Yaadgar Building

**Access Audit
Of
DCP (Traffic) Office
Ajmeri Gate, Tonk Road, Jaipur
June 30, 2011**

**By
CUTS Centre for Consumer Action, Research & Training
(CUTS CART)**

2. Main Gate

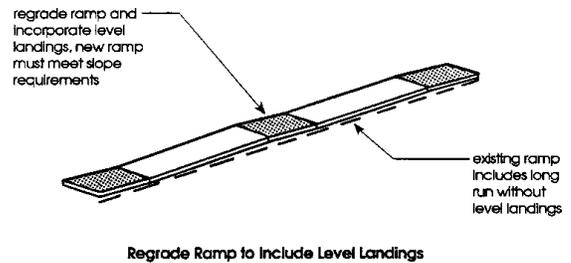
The slope in the main gate entrance ramp may be made more gentle to avoid accidents, since a wheel chair user can pass through own his own but a person from back has to hold the wheel chair (see photo).

from this entrance. Main gate to be painted in bright colors (preferably yellow/red) for easy identification

by persons with low vision from a distance. Unmaintained road trapped small wheels of the wheelchair and can cause trip hazard also for persons

Periodic General maintenance of the road should be undertaken.
(The models of ramps has been shown herewith)

7. Accessible Toilet

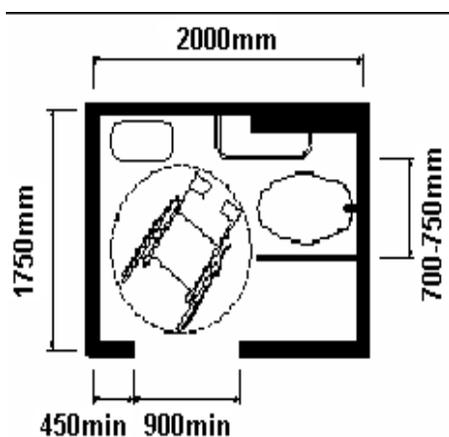
- A. In total there are two toilets in this office which were visited by access audit team. At least one toilet in a two storey building should be made accessible. In the end near police thana office there is one toilet and at same place at first floor there is another toilet. Directional signage for the same to be displayed at the corridor leading to the same, visible from the courtyard. A

minimum of one toilet compartment should have enough floor space for wheelchair in the office.

One of the major difficulties for the PwDs is non-availability of accessible toilets. It is therefore proposed to either convert at least one toilet on each floor into a disabled friendly toilet as per the specifications given below.

- Toilet size: 2000mmX2000mm
- Door size at least 900mm
- Comode height 450-500mm
- Railing Height 700mm
- Quarter Turn Tap
- Alarm Bell at 450mm
- Kick Plate 250mm
- Washbasin Top 750-800mm
- Grab Bar Top- 1500mm
- Urinal Grab Bar Bottom- 1000mm
- Mirror Top with tilted mirror(100mm)- 2000mm

C. Washbasin

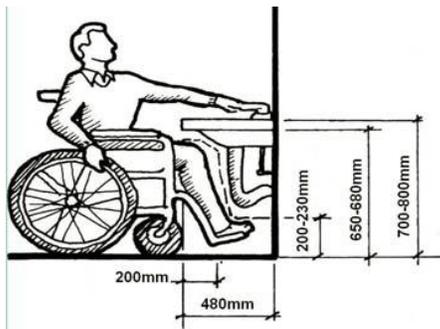
- With dimensions 520mm and 410mm, so mounted that the top edge is between 700mm-800mm from the floor; have a knee space of at least 760mm wide by 200mm deep by 650mm-680mm high.

- Lever type handles for taps are recommended.
- Mirror's bottom edge to be 900-1000mm from the floor and the mirror may be inclined at an angle.

E. Accessible Urinals

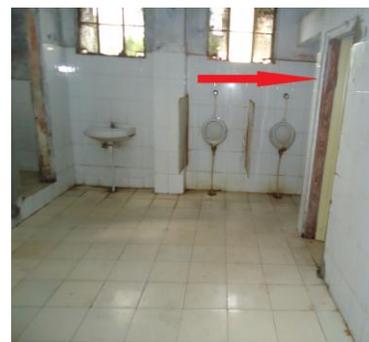
- At least one of the urinals in the Gents toilet should have grab bars; installed on each side and in the front of the urinal to support ambulant persons with disabilities (for example, crutch users).
- The front bar is to provide chest support; the sidebars are for the user to hold on to while standing.
- Urinals shall be stall-type or wall-hung, with an elongated rim at a maximum of 430mm above the finish floor.
- A clear floor space 760mm by 1220mm should be provided in front of urinals to allow forward approach. Urinal shields (that do not extend beyond the front edge of the urinal rim) may be

provided with 735 mm clearance between them.

This is the proposed design of the disabled friendly urinals

8. Eclectic Meter Box

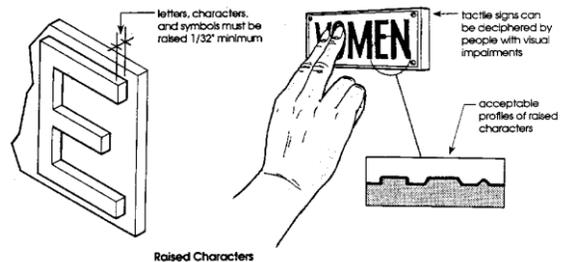
The meter box has been installed at a lower height which is highly dangerous; the people with vision impairment may get hurt. It is proposed that the height of the meter box may be raised to enable clear obstacle free passage for the visually impaired. (see photo)

10. Loose stone strips or tiles are dangerous for PwDs

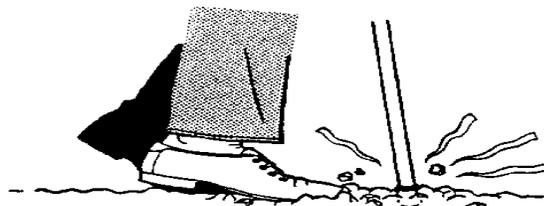
The pictures are showing that on the drains loose tiles

are posing risk of being hurt (see picture below) by any wheelchair user or blind person so these to be fixed with having gentle slope so

that wheelchairs can be passed through easily. As the access audit team found that it was quite risky to cross the pathways from the highlighted areas which are common in the Yaadgar building in the pathways and galleries at ground floor right from entrance to all the corners of building. (See pictures)

RAMP

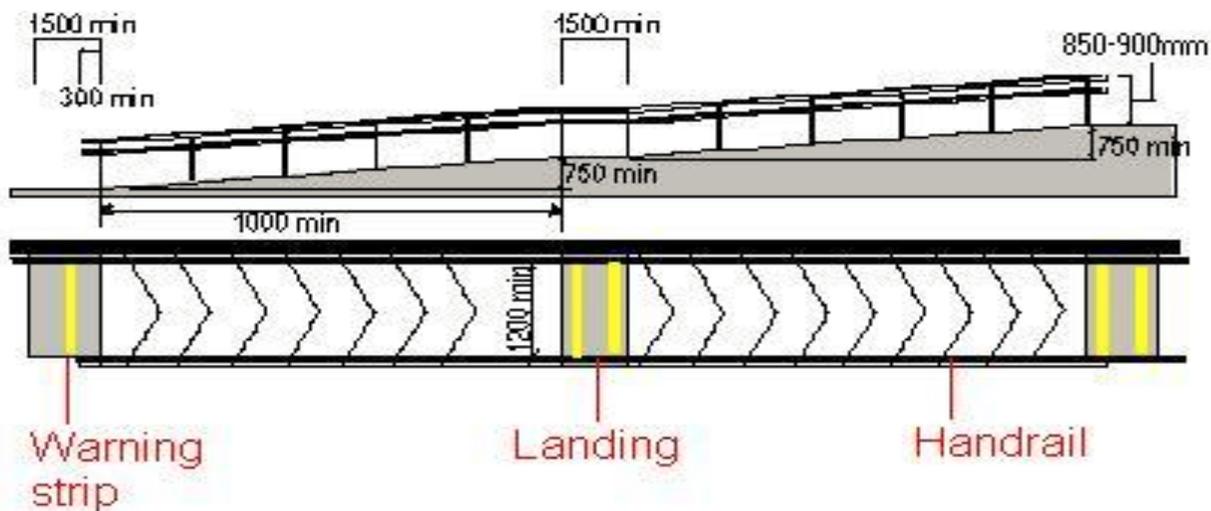
- Indoor- Gentle slope of 1:12 max.
- Outdoor- For first floor and above 1:15 or 1:20 gradient ramp is advised depending upon Availability of space.
- Landings - every 750 mm of vertical rise clear space of 1500mm x 1500mm minimum.
- Ramp width to be 1200 mm or more.
- Handrails to be on both sides at a height of 850mm-900mm; both ends to be rounded and Grouted and extend 300mm beyond top and bottom of ramp.
- Surfaces (ramp + landing) should be slip resistant.
- Strip of warning blocks should be placed 300mm before and after the ramp edges.

HANDRAILS

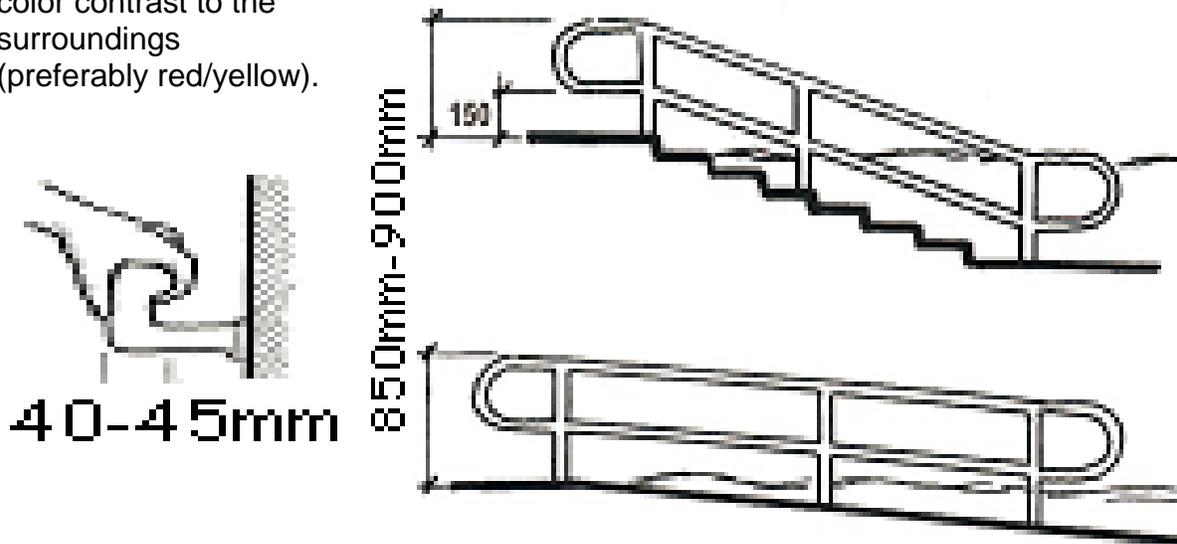
- Should be circular in section with a diameter of 40-45mm.
- At least 45mm clear of the surface to which they are attached.
- At the height of 850mm-900mm from the floor.
- Extend by at least 300mm beyond the head and foot of the flight and ramp in the line of travel and grouted in the ground.
- Should be in bright color contrast to the surroundings (preferably red/yellow).

Tactile Surfaces: Guiding strip & Warning blocks

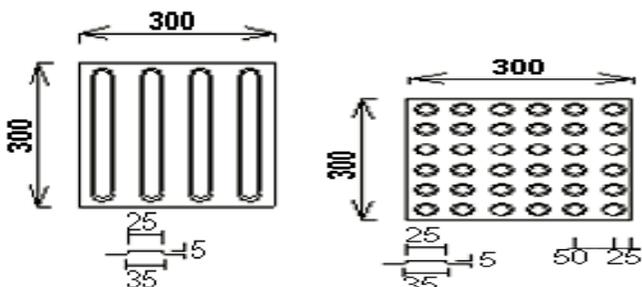
- Line-type blocks indicate the correct path/route to follow.
- Dot-type blocks provides warning signal, to screen off obstacles, drop-offs or other hazards, to discourage movement in an incorrect direction and to warn of a corner or junction. Should be placed 300mm at the beginning and end of the ramps, stairs and entrance to any door.

RESERVED PARKING

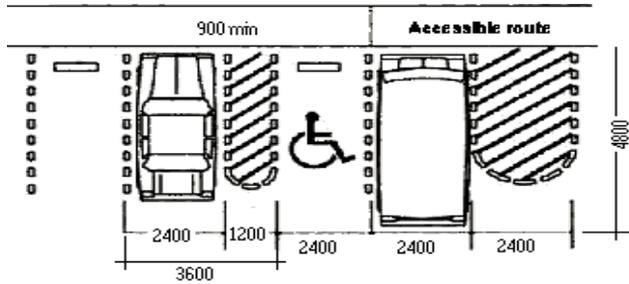
- For staff/students with mobility impairments driving their own vehicles (scooter/car) reserved parking should be provided.
- Parking should be with in 30meters of the main entrance of the building.
- Two accessible parking lots with overall minimum dimension 3600mm x 4800mm, should be provided.
- It should have the access symbol painted on the ground and also on a signpost\ board put near it.
- There needs to be directional signs guiding people to the accessible parking.
- Approach to the parking to be maintained.
- All security guards/staff should be sensitised and well informed about these reserved parking for PwDs.

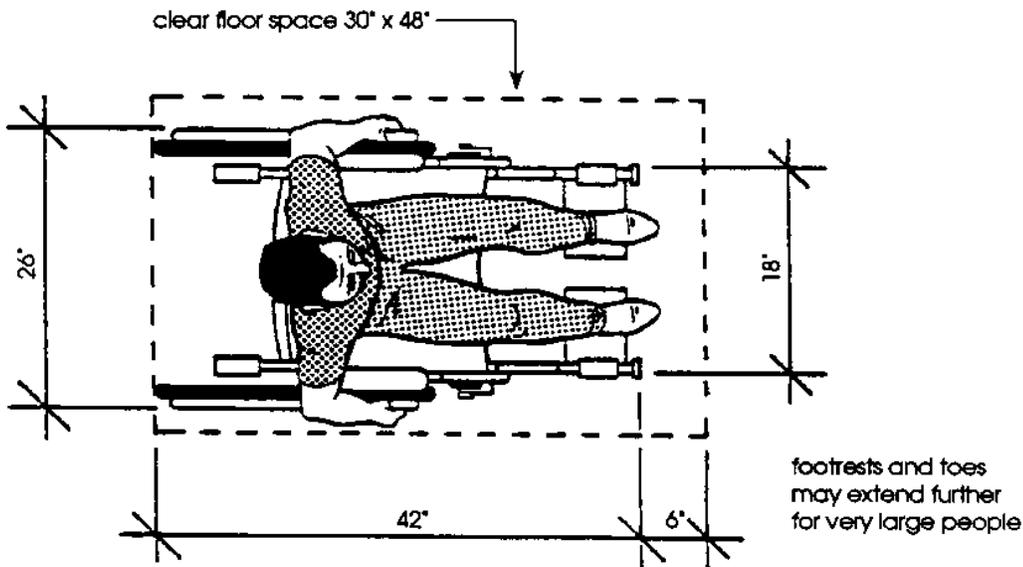
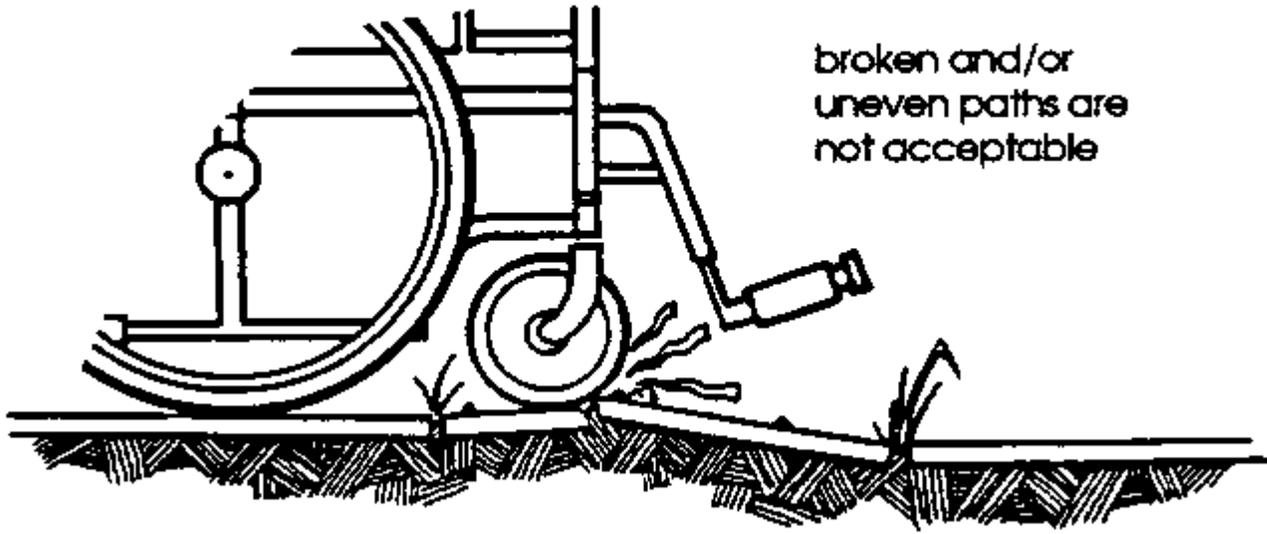
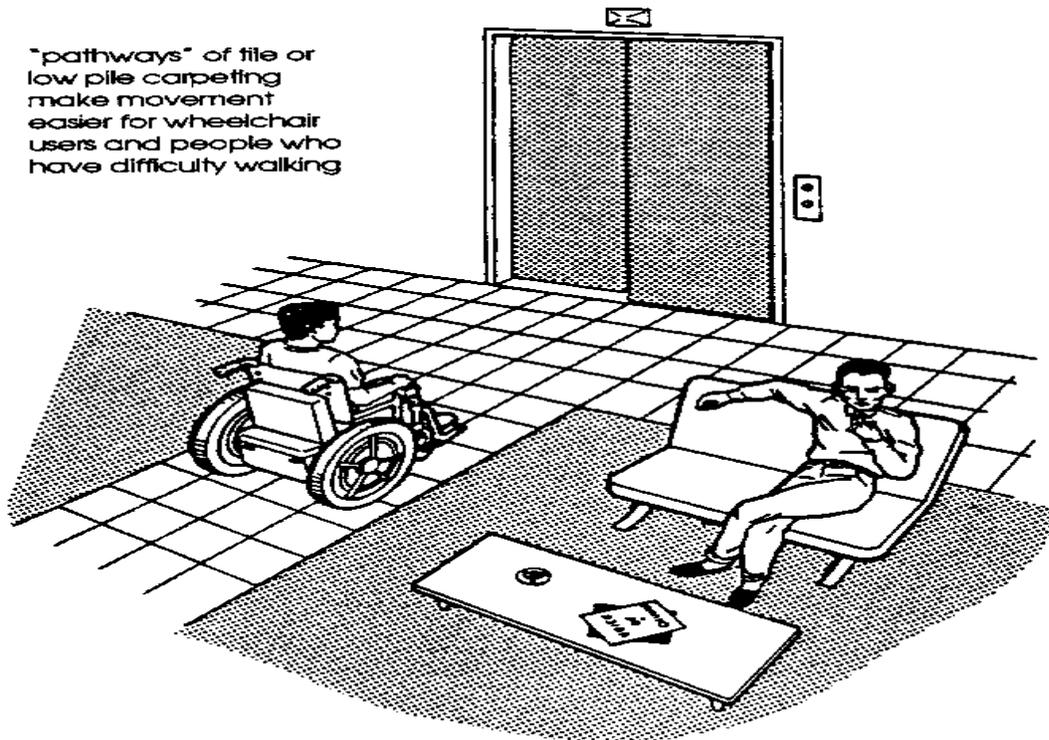
The floor of the building shall be even so that barriers created by pits, cracks, furrows for PwDs which increases the risk for them to be avoided. (See pictures A, B & C below)
